ACEA REFLECTION ON V2X DEFINITION

EVE-61

INPUT FOR POSSIBLE UPDATE OF V2X DEFINITION

WHAT IS COVERED VIA “V2X ENERGY”?

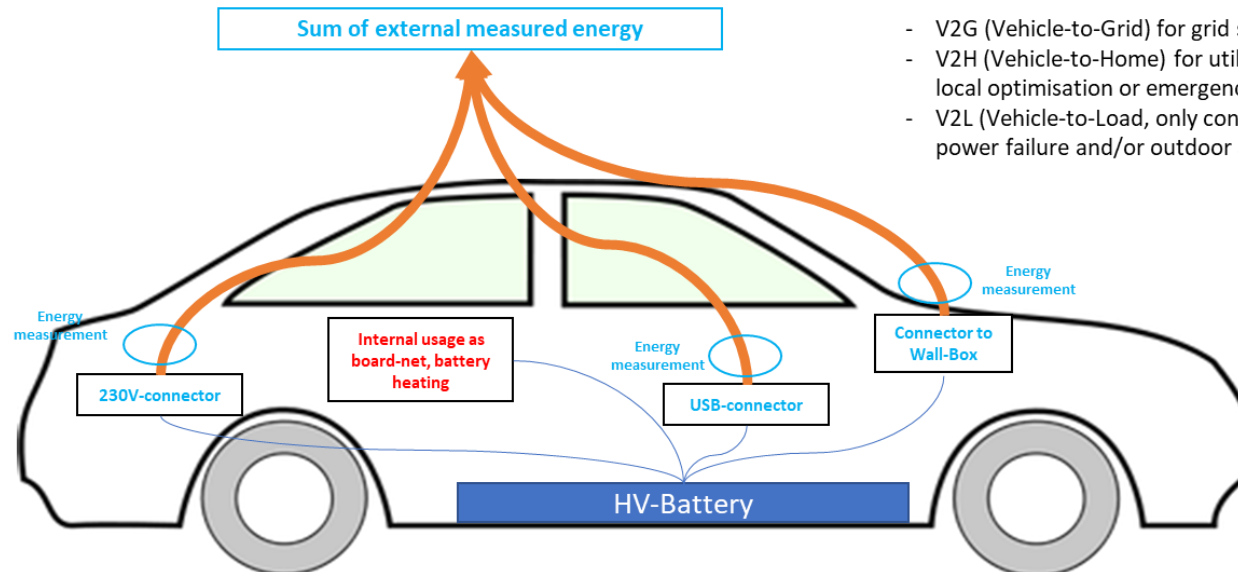
- It need to be clear which energy can be included in V2X energy – discussion slide 1
- Vehicle needs to provide V2X energy value to be read out (see Annex 2, GTR-22) → determination of internal read out (up to OEM)
- V2X energy value need to be verified (verification process currently in discussion) → energy used for external devices need to measured

Pass criterion the verification of onboard displayed V2X energy value

- External measured energy greater than value displayed onboard
- No check of sensor accuracy required...”black/white” decision
